DISTRICT INSPECTOR
INTERNAL MEMORANDUM TO

RE: SUBDIVISION - AQUARIUS DRIVE

FOUNDATION TEST SITES AQUARIUS DRIVE ROTORUA

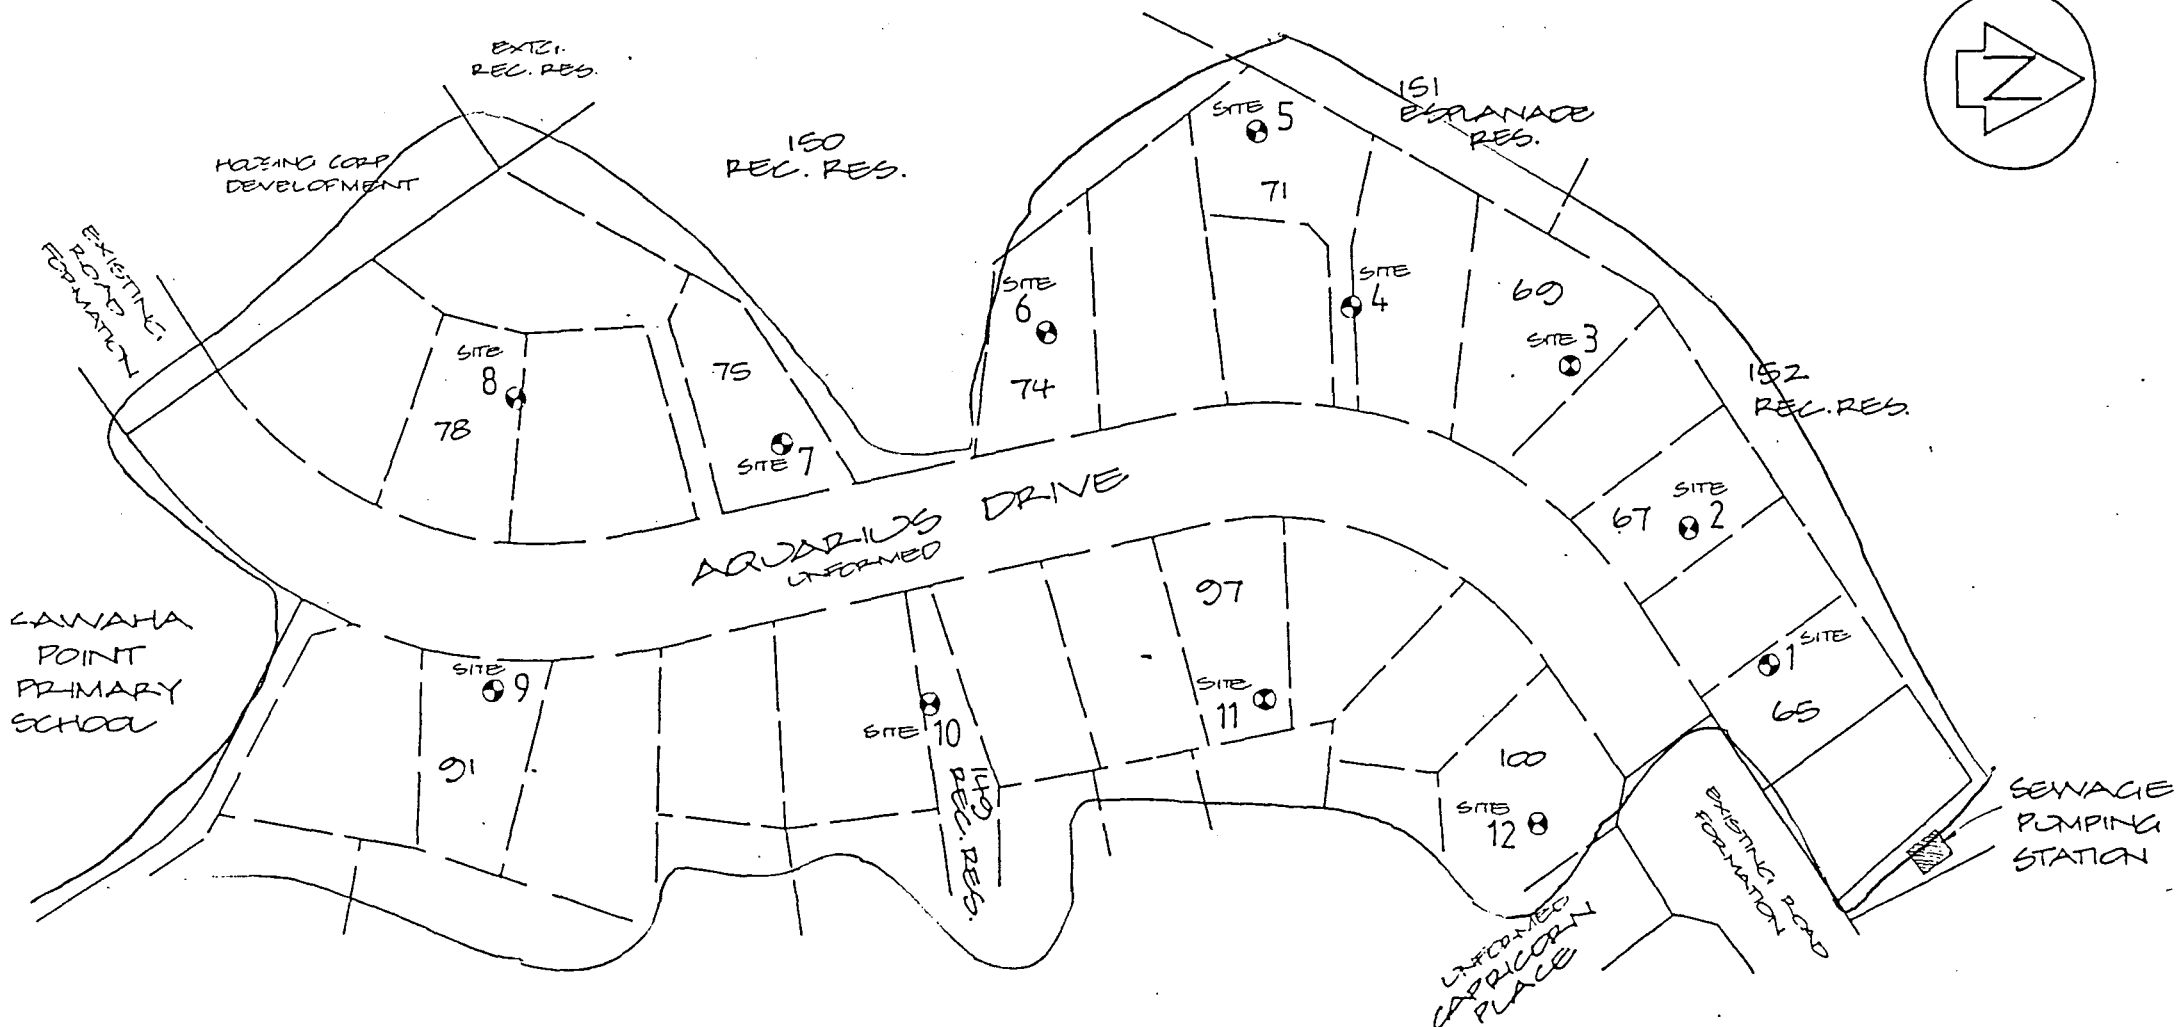
However, from the report, it can be seen that the consolidated fill is underlain by a layer of topsoil and the cut area also includes areas of fine wet sand and silty sediment.

It should be noted that ground levels on the whole of this subdivision, including the previous stage at the foot of the Aquarius Drive hill, have been contoured and shaped in order to provide protection to the house sites, from the adjacent Waiahero Stream. There should be no excavation of the surface to provide house sites. I have noticed that this has already been done in a minor way in Gemini Place.
